ADDENDUM NO. 1

- A. Date: 15 March 2013
- B. From: Bahr Vermeer and Haecker Architects, Ltd.
- C. To: Prospective Bidders.
- D. Project: Lexington Public Schools Lexington Middle School and Community Recreation Facility Addition 100% Contract Documents
- E. This addendum is issued by the Architect to all bidders of record prior to receipt of proposals. Bidders shall acknowledge receipt of this addendum by so indicating on the Bid Form. Failure to do so may subject Bidder to disqualification.
- F. All information and instructions given herein shall become a part of the Contract Documents.

PIPE PENETRATION DETAIL

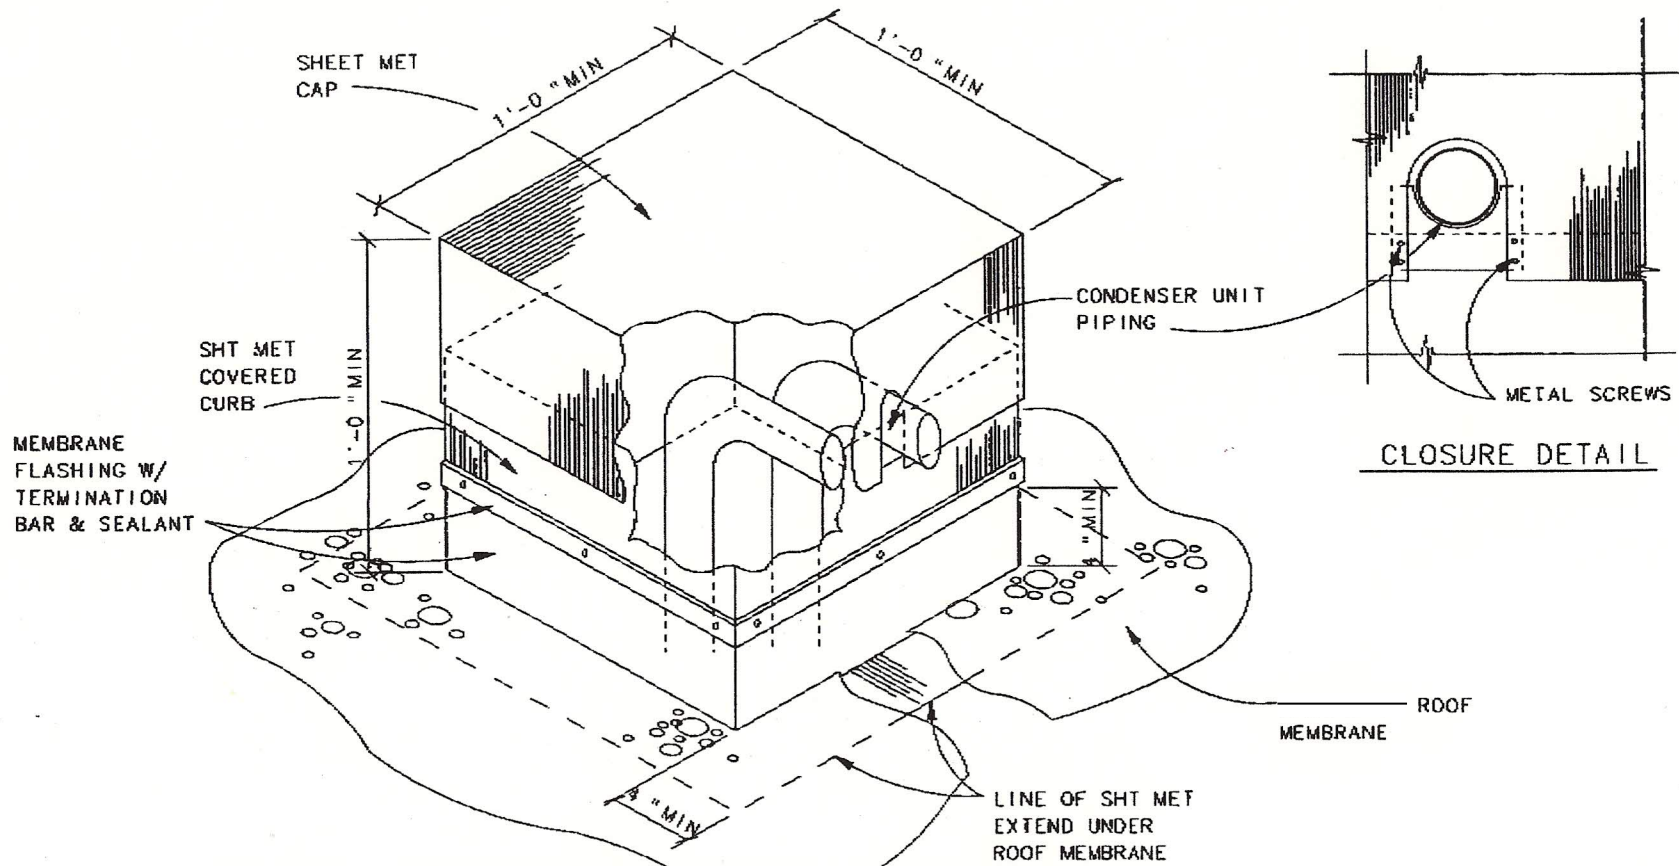
2. Add attached Walk-In Refrigeration piping detail.
 3. Add note to General Kitchen area to see Structural, Food Service, and Mechanical Drawings for plumbing, concrete slab and below slab details.
